UNITED STATES PATENT AND TRADEMARK OFFICE

APPLICATION NO.	FILING DATE	FIRST NAMED INVENTOR	ATTORNEY DOCKET NO.	CONFIRMATION NO.
10/670,227	09/26/2003	Alain Baranger	0514-1119	6829
466	7590	04/11/2005	EXAMINER	
YOUNG & THOMPSON 745 SOUTH 23RD STREET 2ND FLOOR ARLINGTON, VA 22202			NGUYEN, JIMMY T	
			ART UNIT	PAPER NUMBER
			3725

Office Action Summary

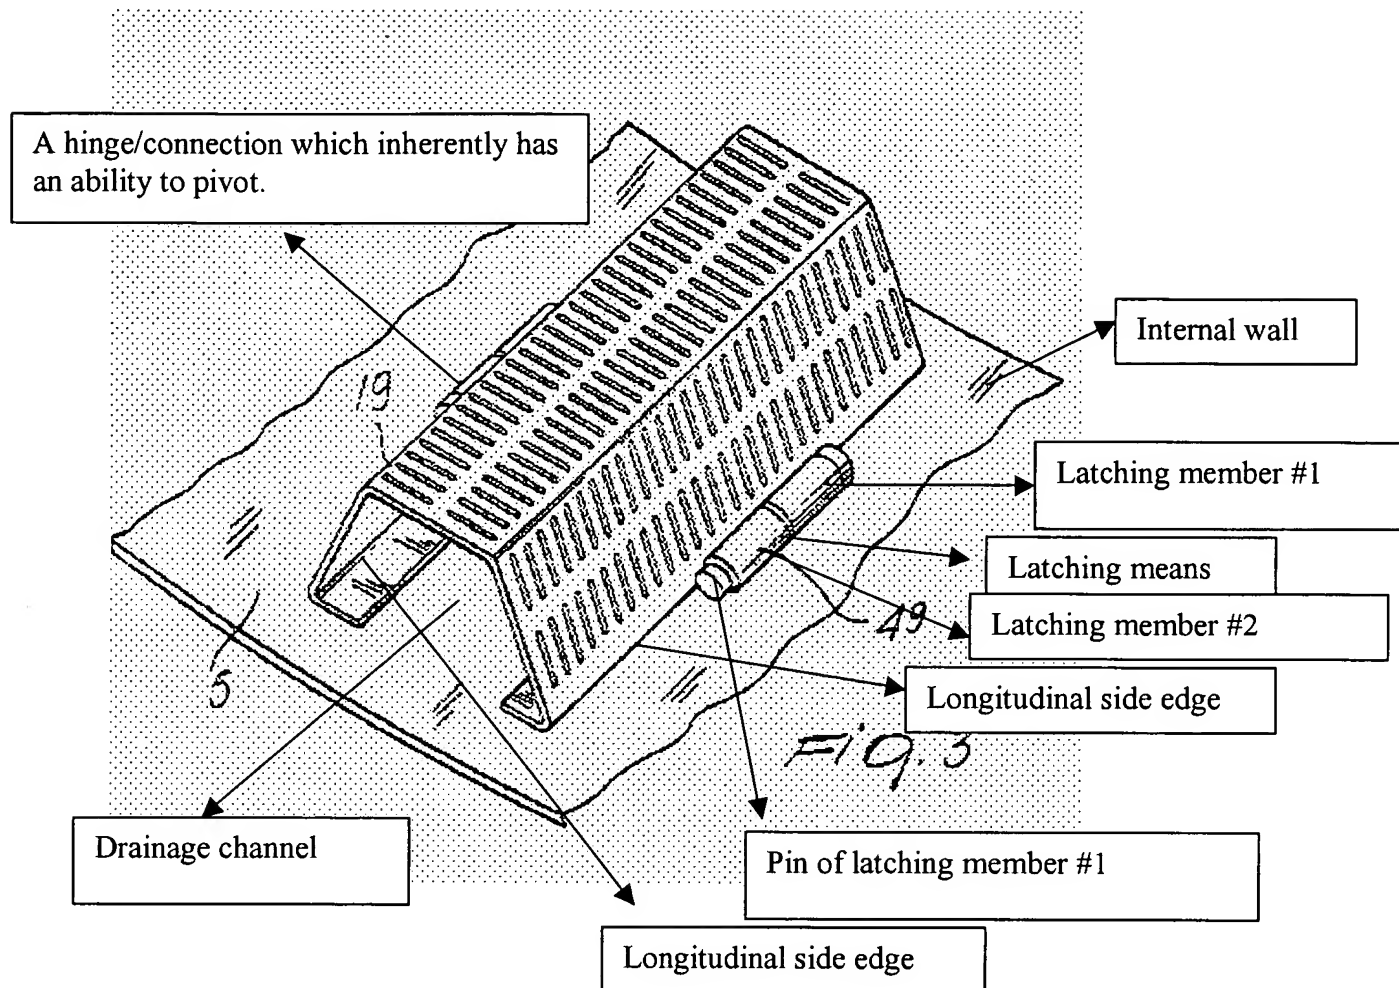
Regarding claim 1, Diotalevi discloses a draining unit for a press comprising at least one elongated, profiled element (19) which contain a plurality of spread-out holes (fig. 3), said element extending along the internal wall (5, fig. 3) of the press and forming a drainage channel together with the wall through contact at two longitudinal side edges (fig. 3), wherein the profiled element (19) is interlocked with said wall at one of its side edges by means of a connection (49) with an ability to pivot. Diotalevi discloses that the profiled element (19) is easily opened (col. 2, lines 51-55) from the vat by utilizing a latching means/hinges (49), therefore, the latching means adapted to lock said profiled element (by sliding the latching means into a pin (see below)) in a position with its two side edges resting against said internal wall so as to form the drainage channel (see the illustration below).

Regarding claim 13, Diotavely discloses the latching means is formed by two members (see illustration above), one (latching member #1) of which is interlocked with the profiled element (119 and the other of which is interlocked with wall (latching member #2) of the vat, the two members being capable of being inter-engaged to lock the profiled element (1) in position and disengaged through translation of said profiled element (1) in opposite directions.
